Addendum No. 1

DATE: December 20, 2022

FOR: **Pike County BRO-B082(32) Bridge County Road 409 Bridge #17600061 Replacement**

BRO-B082(32) CR 409 BRIDGE
BRIDGE #17600061 OVER LICK CREEK
PIKE COUNTY, MISSOURI
TYPICAL SECTIONS & QUANTITIES

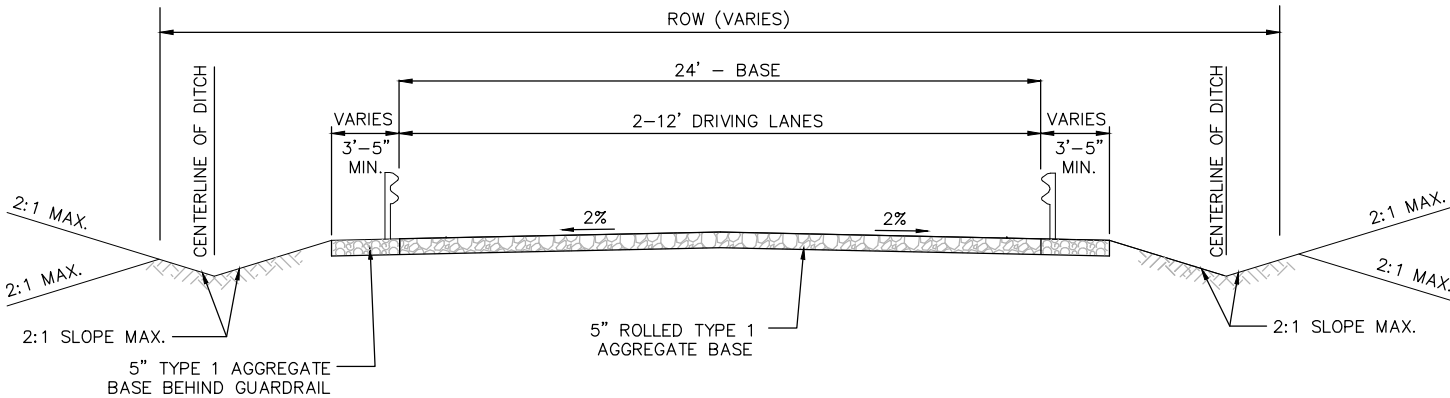
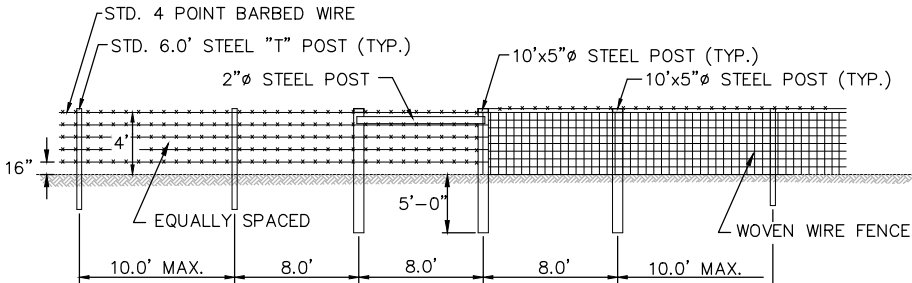
Question 3: Are you wanting a 25-feet Crashworthy or 50-feet Crashworthy for this project?

Change made to Drawings Sheet C-2, Roadway Quantities, Type A Crashworthy End Terminal, issued on the original set

Answer 3: The Type A Crashworthy End Terminals for this project are 25 feet in length.

GENERAL NOTES AND QUANTITIES

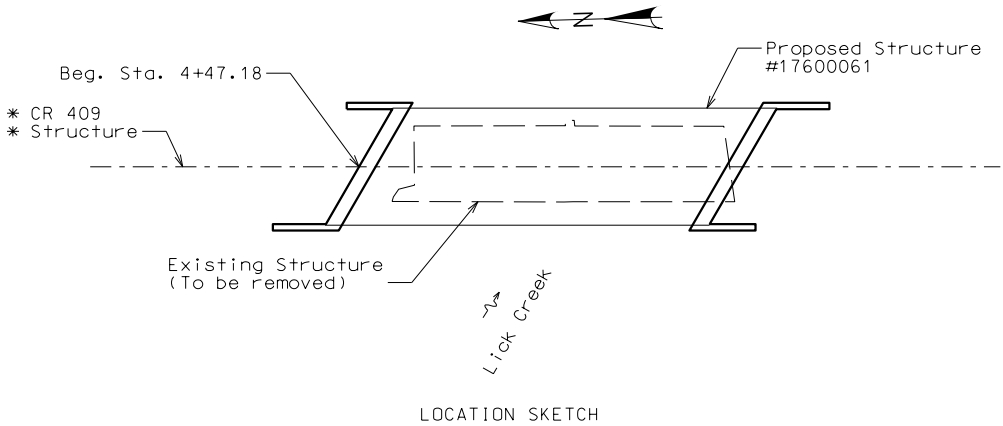
Question 5: The quantity is incorrect on the bid form for pile point reinforcement. I believe it should be 10 each instead of 8 each.

Change made to Itemized Bid Form and to Drawings Sheet S-2, Estimated Quantities, Pile Point Reinforcement quantity, issued on the original set

Answer 5: Quantity of Pile Point Reinforcement is changed from 8 to 10 on the Bid Form and Drawings Sheet S2, Estimated Quantities.
